RE: Response by Alabama Power Company to FERC letter of August 11, 2011 (Project No. 349-173) Martin Dam

Responses Reference Questions in the AIR:

Figure 1a. Martin 1998 Summer-Fall Pool Elevation vs. Guide Curves

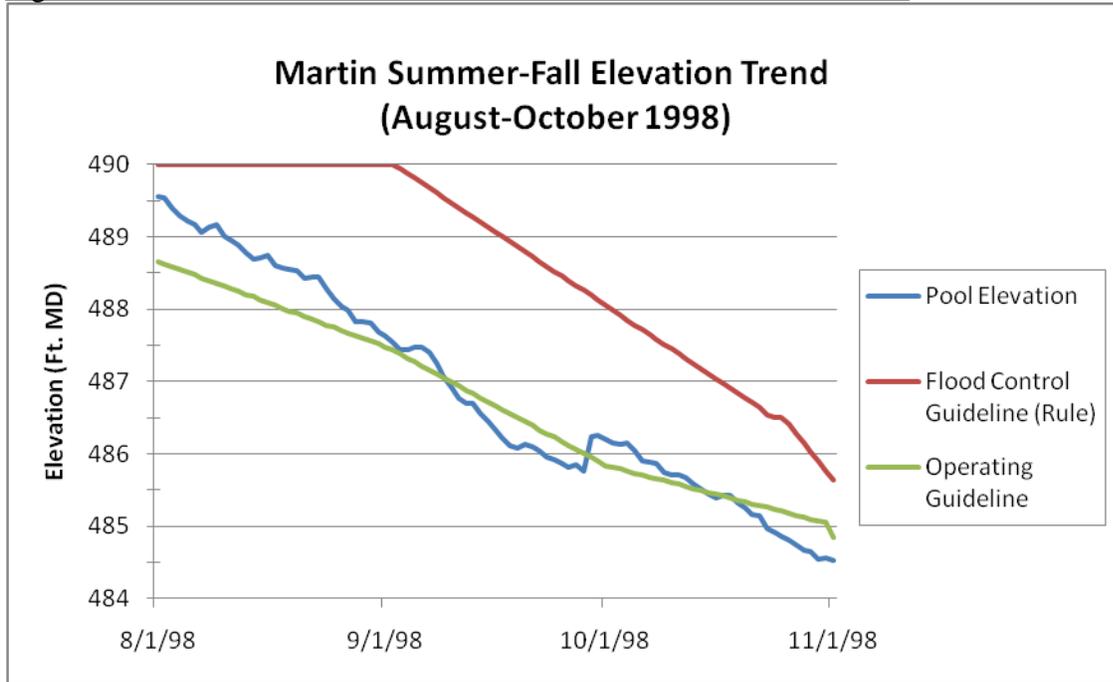
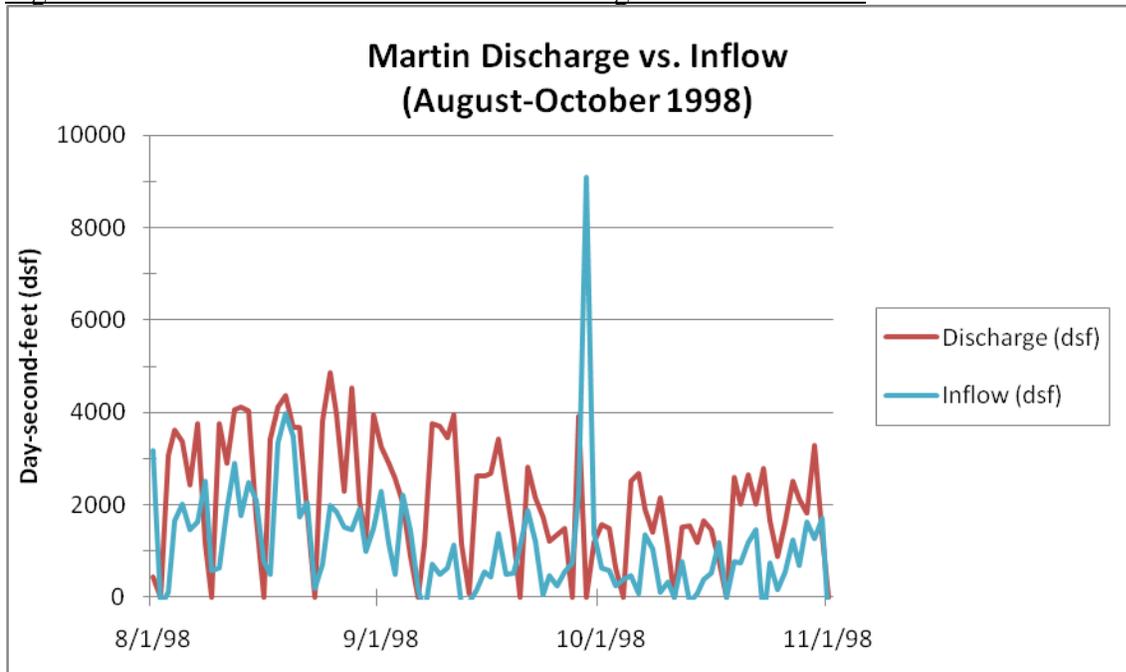
Unfortunately, Alabama Power offers no historical evidence to support their contention that they have and will strive 'to maintain the maximum reservoir elevation possible' according to past and proposed modes of operation. Simple graphical depictions of pool elevations relative to flood and operating guide curves together with accompanying hydrographs of Martin Project inflows versus reservoir discharges could show how well Alabama Power's actual operations did in fact 'maintain maximum reservoir elevation possible..' given past opportunities to do so. We recommend, as shown below in Figures 1a and 1b, that Alabama Power graphically depict the impacts of their operations for the months of August through October for the non-drought years that are listed in their response to Question 9, for conditional criterion 1 and explain how operations were impacted by these guidelines. The years 1998 and 1988 are good contrasting examples of Alabama Power's apparent proclivity to not achieve and maintain the maximum reservoir elevation possible, even when hydrologic conditions indicate that a higher pool elevation could be maintained to accommodate the recreational and related socio-economic beneficial uses of a possible fuller pool.

For 1998 and other years with wetter than normal fall seasons, it appears the operating guide curve serves as an operational target so that discharges from generation are increased to offset inflows that might otherwise facilitate the attainment and stability of higher pool levels during this seasonal period.

Figure 2. Martin Summer-Fall Elevation Trend, August-October 2009

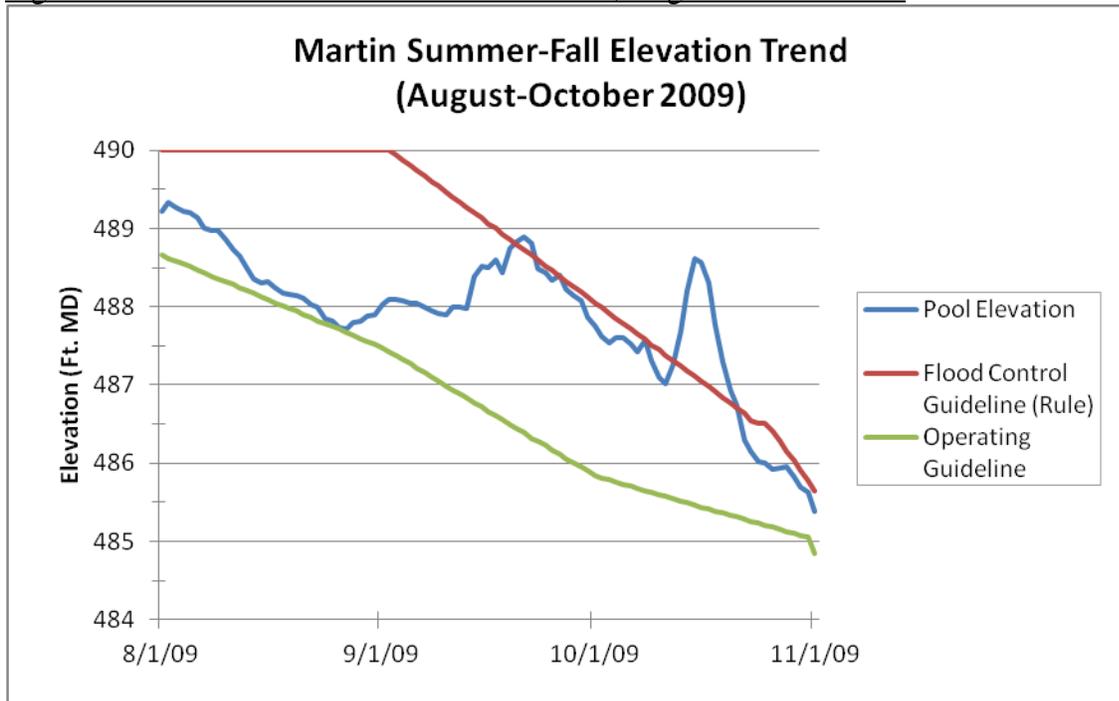
Another related impact the existing (and proposed) rule curve has during the months of the proposed conditional Fall extension (September-October) is a 'yo-yo' pool elevation effect during wetter years. The progressive decrease in elevation of the rule curve requires water to be released for flood control compliance and the pool elevation drops accordingly. But when inflows increase during this period, the lake 'pops' up often above the flood curve and the lake is dropped back down until the next inflow flux. This yo-yo effect disrupts recreation access to the lake and contributes to the damage of floating docks, piers and watercraft subject pool level changes. The most recent example of this is the Fall of 2009 as shown in Figure 2.
